Modification Sheet No. ELRS / MS / 0323

1.0 Title: Modification to improve reliability of headlight circuit for working of headlight while passing neutral section, earlier issued vide RDSO Modification Sheet No. WAM4/173, WAM4/181, WAM4/193 and ELRS/MS/288.

8.0 Modification Drawing No: SKEL-4670.

REF : SER/No.CEE/RS/ CIR/046	SCALE : NTS	APPROVED BY: <i>R</i>
MODIFIED CKT. FOR WORKING OF HEAD LIGHT WHILE PASSING NEUTRAL SECTION		FIRST ISSUED
RDSO, ELEC. DTE, SKEL-4670		SUPERSEDES SKEL-4242
		SUPERSEDED BY DSE-1

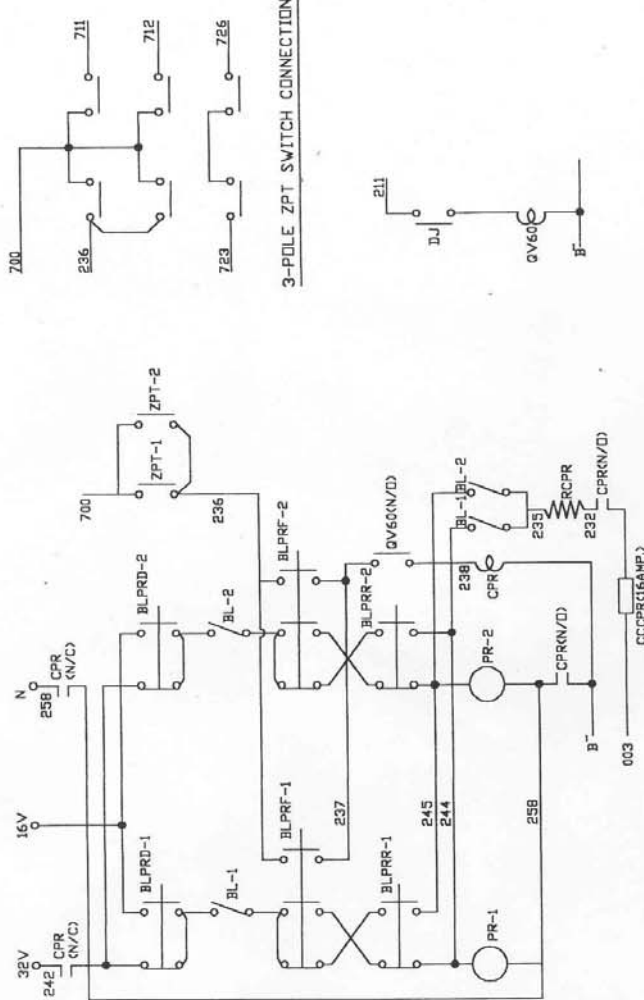
To overcome the problem a simplified circuit has also been suggested by SER, changing the connection at ZPT, facilitating elimination of blocking diodes and also modification in circuit of CPR contacts branch to bypass BLPRD/ BLPRR/ BLPRF during DC operation of headlight (while negotiating neutral section).

- Connect the CPR coil feeding circuit at ZPT switch as shown in RDSO's drawing no. SKEL-4670 to take the feed from cable no. 700 instead of 711 & 712.
- Disconnect the parallel connection of N/O interlock of BLPRF.
- Connect N/O interlock of BLPRF in series with N/O interlock of QV60 and CPR coil.
- Connect spare interlock of BL in series with RCPR as shown in RDSO's drawing no. SKEL-4670.
